Validation Report

Validation of CDM project for
**Recovery and Utilization of Associated Gas at
Pondok Tengah LPG Plant – PT. Yudistira
Energy**

LRQA Reference : A20119-M
Version 06.4
Date : 10/12/2012
Work carried out by : Ankush Jain
Cholid Bafagih
Dodi Budiristio
Work verified by : Prabodha C Acharya
Sean Cuthbert
Michiaki Chiba

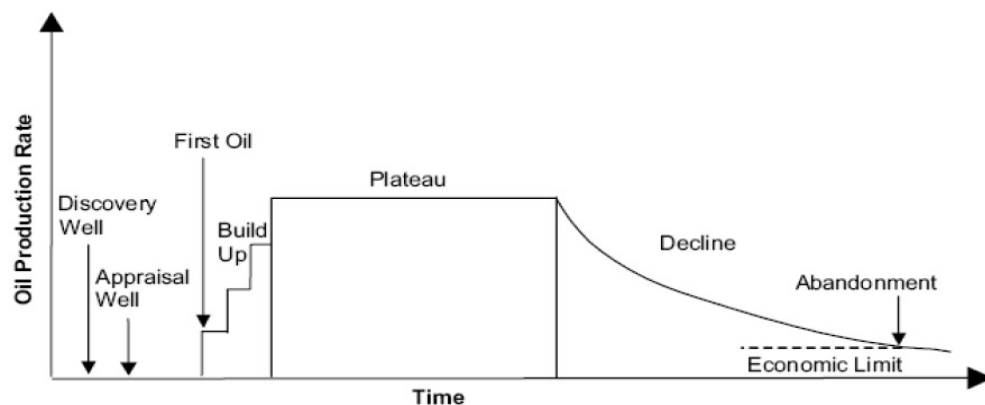
6. Nature of responses provided by the project participants:	<p>The PDD was revised to include the description of technology as environmentally safe and sound; age and average lifetime of equipments; efficiency; monitoring equipments and their locations; emission sources and gases; existing and forecast energy and mass flows and balances; equivalent SI units.</p> <p>Inclusion of load factor is not relevant as the loading is always limited by the availability of associated gas from the oil wells, therefore only efficiency is included.</p> <p>Project flow diagram was revised to represent that only a part of lean gas will be consumed and remaining will be supplied further.</p>

7. Assessment of such responses:	<p>Validation team confirmed the revised PDD correctly includes the following.</p> <p>Description of the technology is included in the revised PDD and the technology is environmentally safe and sound as confirmed from the sectoral expertise of LRQA.</p> <p>Description on age and average lifetime are included in the revised PDD and validated from review of the decree of ministry of finance, decree no. 96 of the year 2009 and from the sectoral expertise of LRQA.</p> <p>Description of efficiency is included in the revised PDD and validated from the process simulation and sectoral expertise of LRQA.</p> <p>Description of monitoring equipment and their location in the system is correctly described in the revised PDD and has been confirmed from the site visit and interview of the PP.</p> <p>Description of the emission sources and gases involved in the project activity and validated from the site visit, sectoral expertise and review of the applied methodology.</p> <p>Description of existing and forecast energy and mass flows and balances of the system is correctly included in the revised PDD and validation team confirmed from the review of FSR, simulation and based on the LRQA sectoral expertise.</p> <p>All the values are provided in the equivalent SI units in the revised PDD.</p>

Revised flow diagram correctly presents that only a part of the lean gas is used in the system. Validation team confirmed this from the review of FSR, site visit and sectoral expertise of LRQA.
